MEMORANDUM

SUBJECT: SF-21-032– Sterling Ranch Filing No. 3
First Submittal

Engineering Division

**WEST FL HAZLETT DRIVE PROFILE PROFILE
STA 0+00.00 TO 1+43.12**

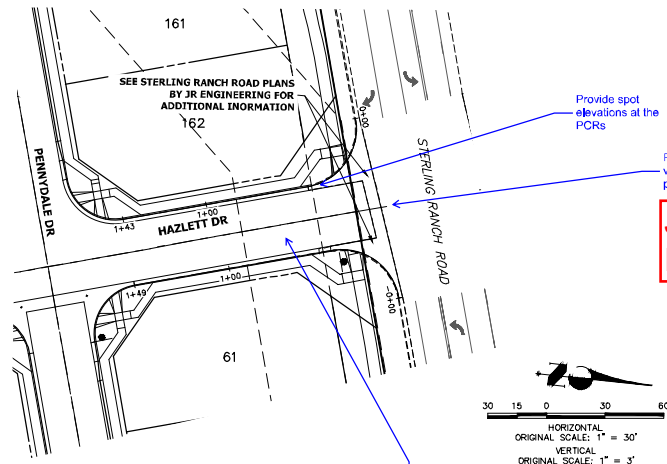
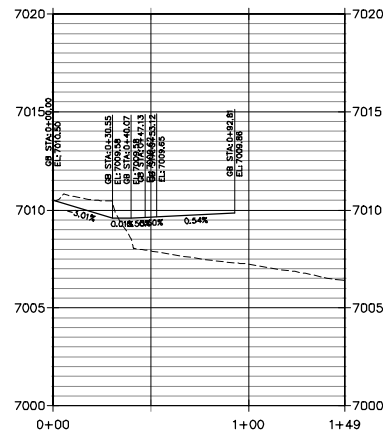
label warping and cross-slopes

Provide spot elevations at the PCR's

JR Response: Moved Profiles

JR Response: Added

JR Response:Updated

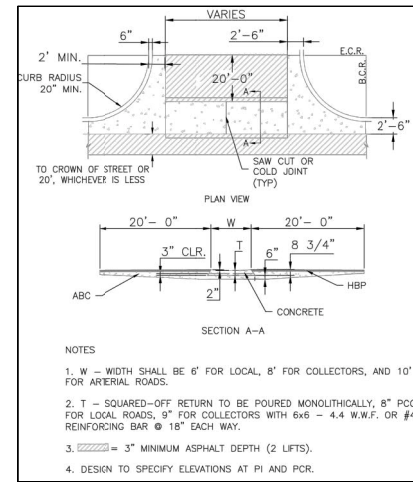
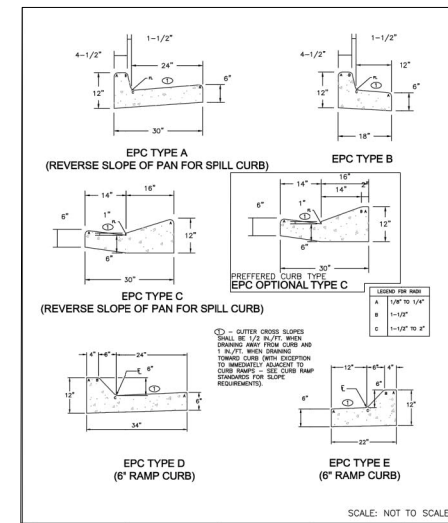
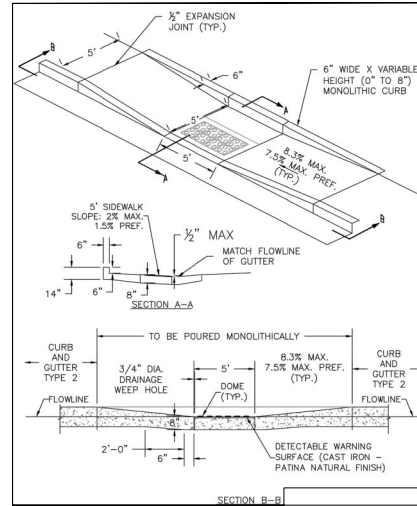
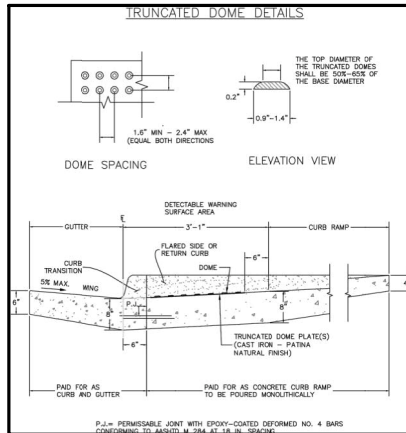
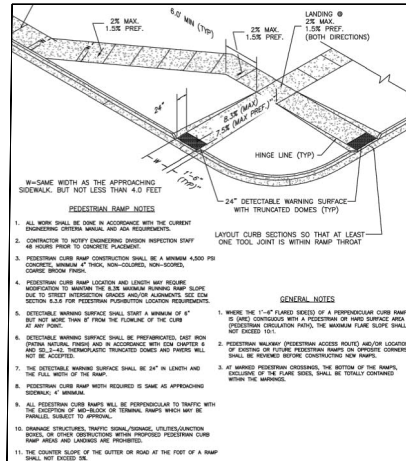
Provide trail and maintenance access road cross-sections

JR Response: Updated
